# ADDENDUM #03

DATE: August 30, 2022  
 PROJECT: Sininger Hall – School of Business (RFP 23-002)  
 FROM: Baker Architecture + Design  
 TO: All Prospective Offerors

## Addenda Summary:

B\_AD PROJECT # 2104  
FILE: 21092\_M101.dwg  
DATE: 08/09/2022  
DRAWN BY: MO  
CHECKED BY: WAY

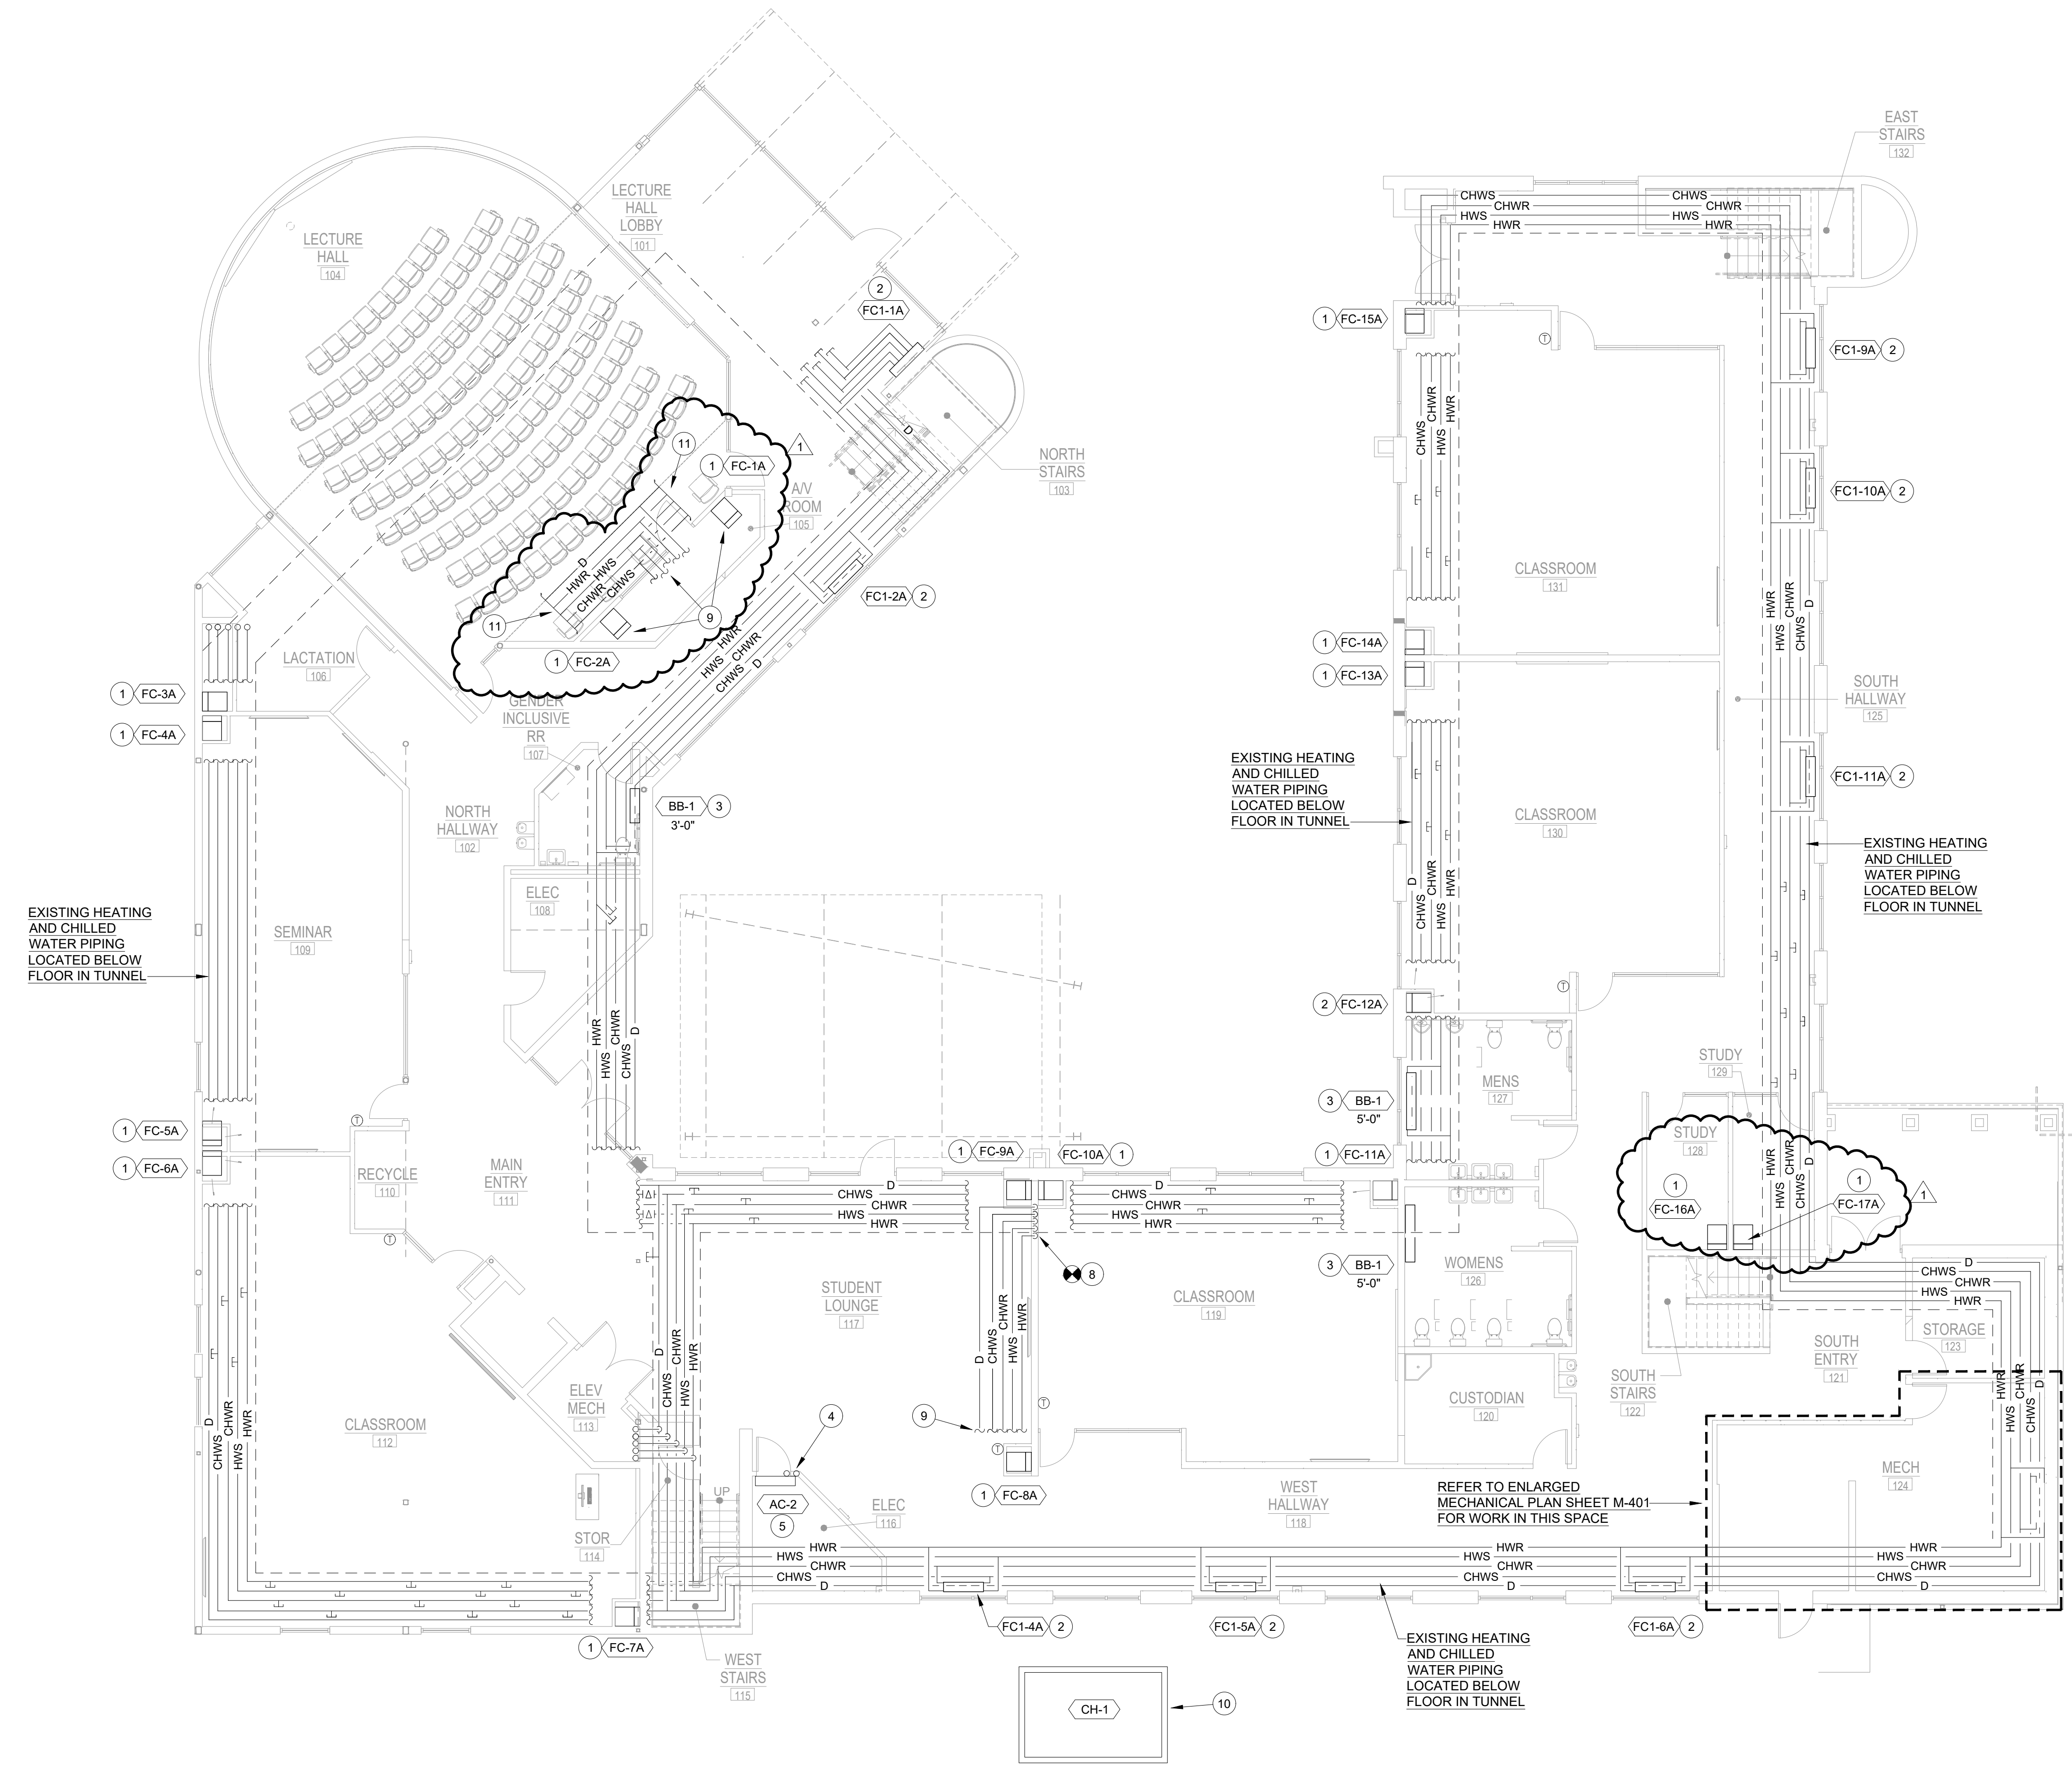
Sheet M-101 – Added HVAC piping for Lecture Hall fan coil units and added fan coils for Study Rooms 128 & 129.

**SECOND FLOOR HVAC PIPING PLAN**  
SCALE: 1/8"=1'-0"

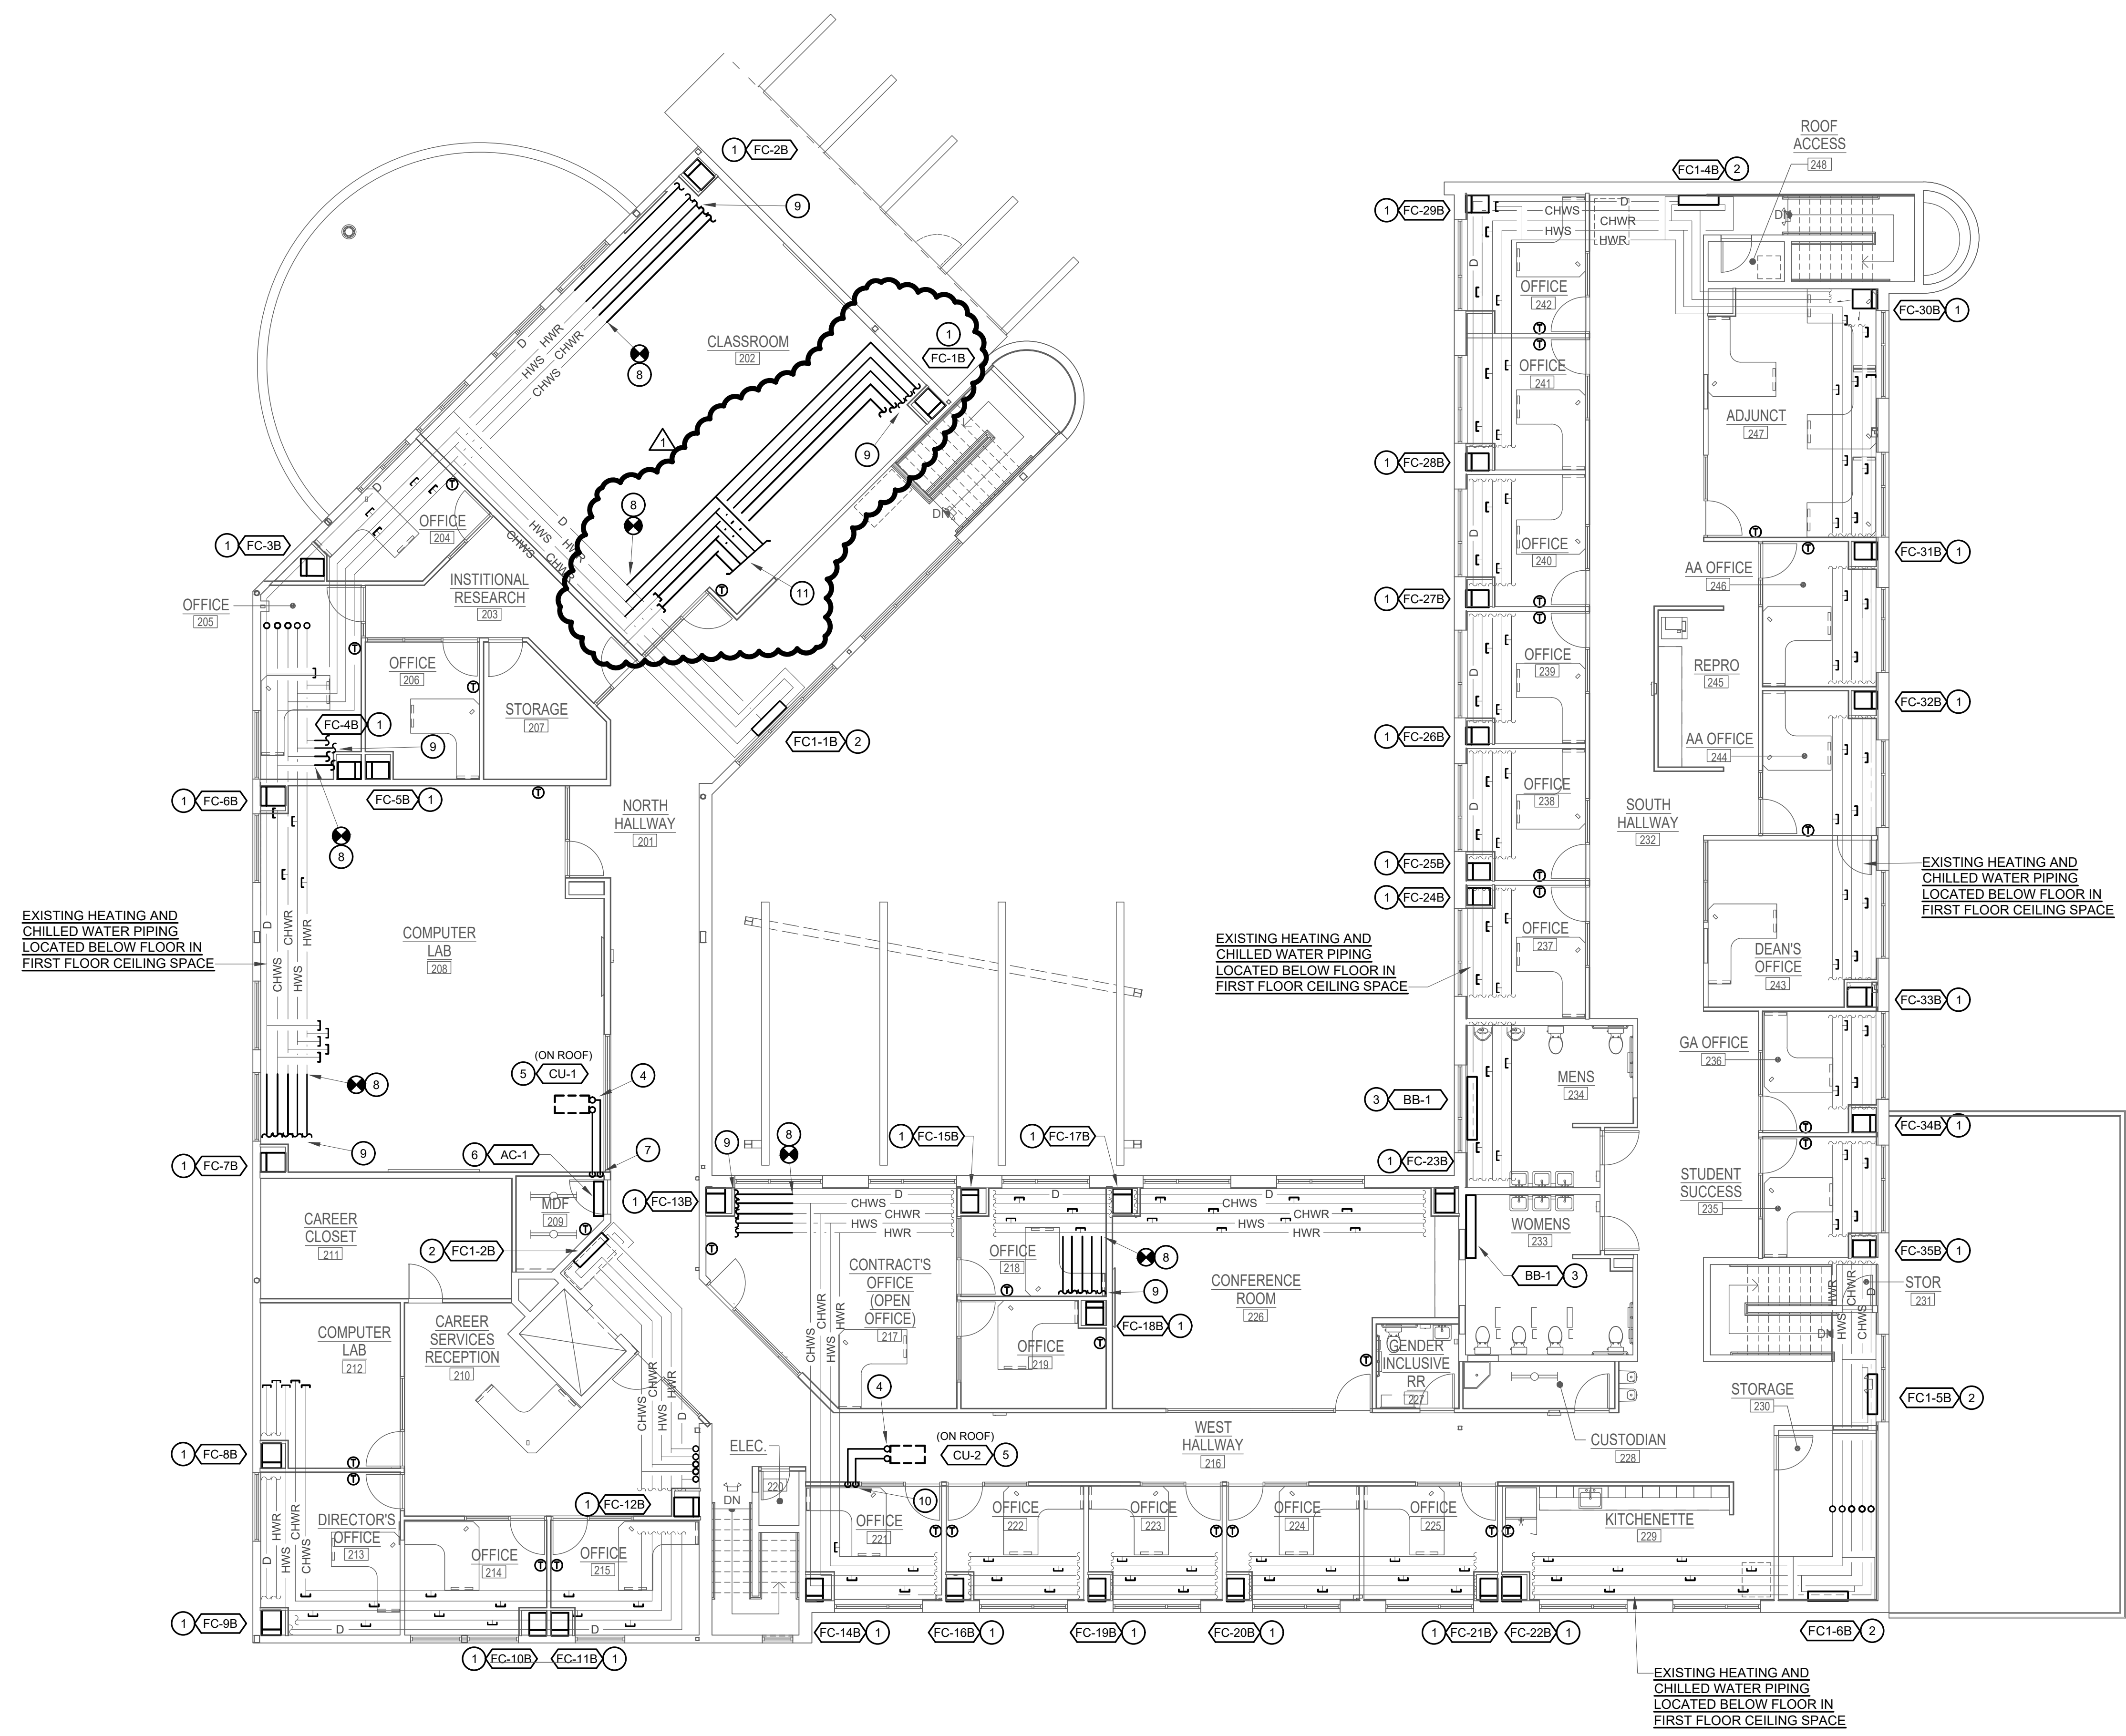
Sheet M-102 – Added HVAC piping for Lecture Hall fan coil units.
